CITY PLANNER'S REPORT

Tidal Wave Express Car Wash/Application CUP21-0004

RE: MVOB Review and Trip Comparison
Proposed Tidal Wave Car Wash – 2024 McKelvey Road
Maryland Heights, Missouri
CBB Job No. 008-21

Figure 2: Conceptual Site plan (Provided by others)

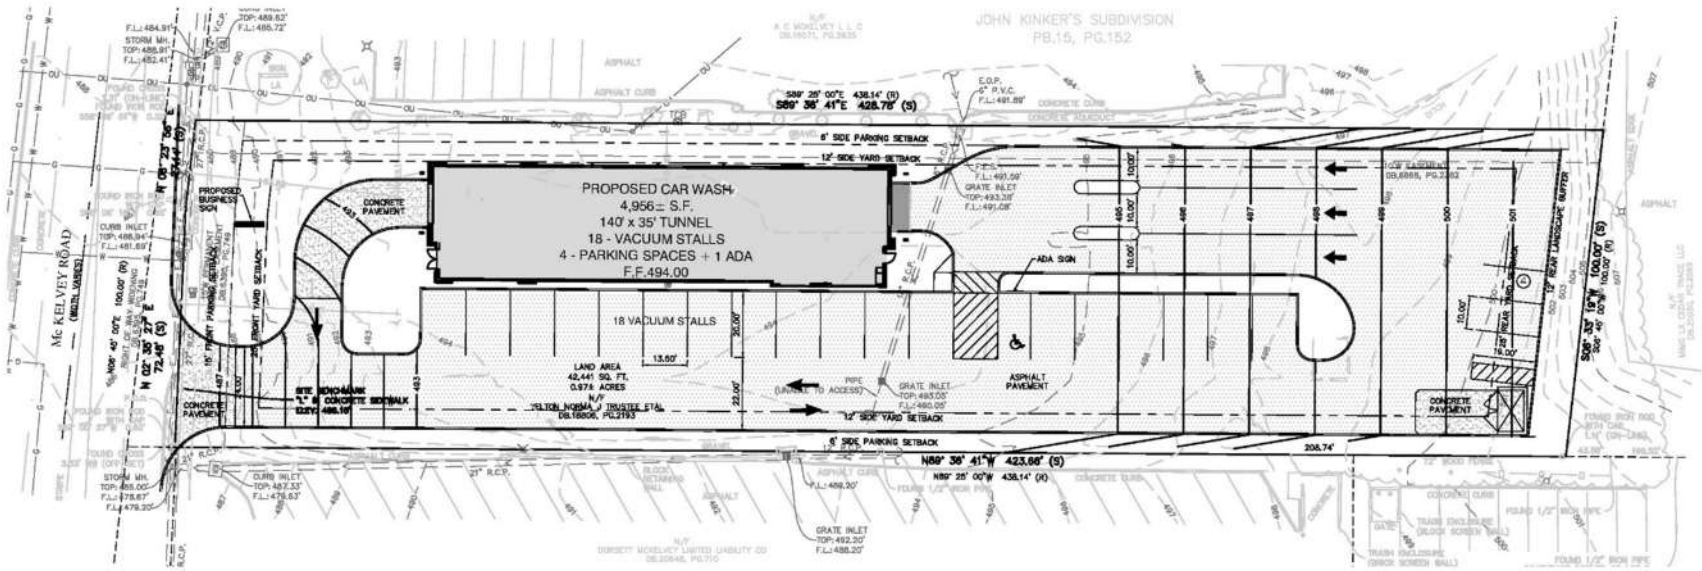
The Preliminary Site Plan, dated January 28, 2021, provided by Civil Engineering Design Consultants (CEDC) combines the two existing taco bell access drives into one drive on the south end of the site and serves both inbound and outbound flow at one location. **Figure 2** illustrates the current site plan layout and proposed access.

- A. **Minimum Lot Area.** Twenty thousand (20,000) square feet. **Satisfied. The Lot Area is ± 0.97 acres or more than 42,000 SF.**
- B. **Minimum Lot Width.** The minimum lot width at the building line shall be one hundred fifty (150) feet. **Not Satisfied. The lot width is approximately 100 feet.**

- A MVOB requires a minimum lot width of 150 feet, while the lot is approximately 100 feet wide.
- A trash enclosure is within the 25-foot rear yard. The trash enclosure approximately 12-15 feet of the rear property line.

Figure 3: Drive-Thru Storage

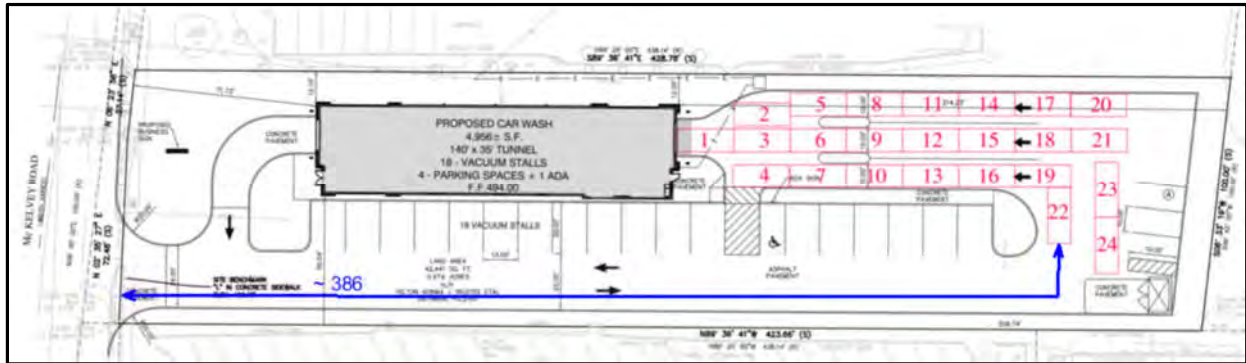
1. *Storage Length.* Stacking spaces equivalent to ten (10) times the capacity of the car wash shall be provided. One (1) stacking space is equal to twenty-two (22) feet of pavement length. **Satisfied.** Based on information from the owner, there is typically a maximum capacity of 4 vehicles in the tunnel. Based on the code, 40 stacking spaces (or 880 feet) of storage should be provided with half exclusive use. The site plan includes enough stacking to accommodate approximately 915 feet of total stacking (or 41 vehicles) on the site before potentially impacting McKelvey Road, see Figure 3.

In order for the expected queues to extend beyond the exclusive use area proposed (24 vehicles), approximately 86 to 115 vehicles would need to enter the car wash during one hour, assuming a 40 second service rate (90 washes/hour) and 30 second service rate (120 washes/hour), respectively. Considering 86 to 115 vehicles to the car wash is 2 to three times the typical

- 2. *Exclusive use. The drive-thru lane shall be used exclusively for drive-thru vehicles for a distance equivalent to fifty (50%) percent of the required storage length of the car wash. Satisfied. The exclusive use area includes three lanes to accommodate approximately 24 vehicles (528 feet), see Figure 3.*

Figure 4: Reinforce One-Way Traffic Flow at Drive-Thru Exit

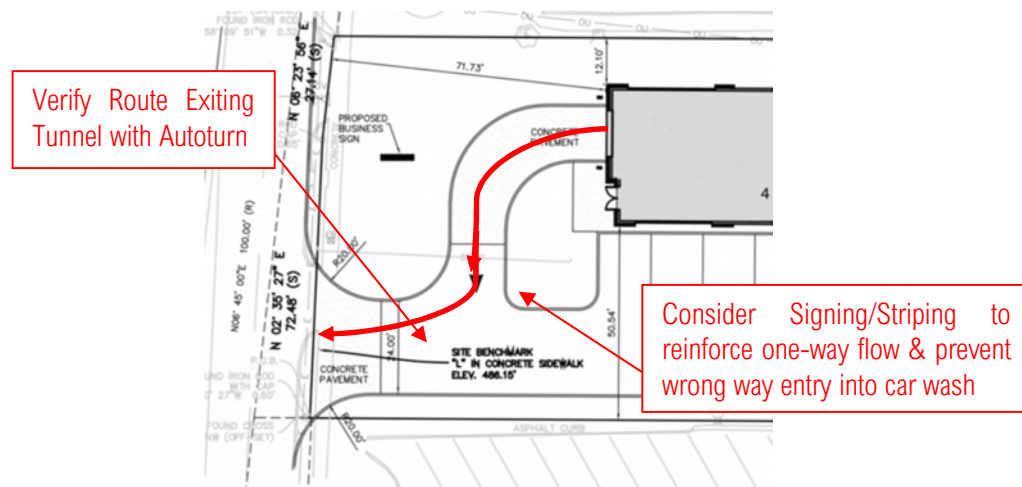
- The site civil engineer should perform AUTOTURN on the turns within the site to verify appropriate turning radii are provided. Specifically, the route exiting the car wash tunnel to McKelvey Road. The vehicles exiting the wash should not cross the centerline of the main drive aisle, see **Figure 4**.

- Signing and/or pavement marking could be installed at the tunnel connection to the main drive aisle to clearly convey the car wash tunnel exit (one way) so that patrons do not attempt to enter the car wash backwards, see **Figure 4**.
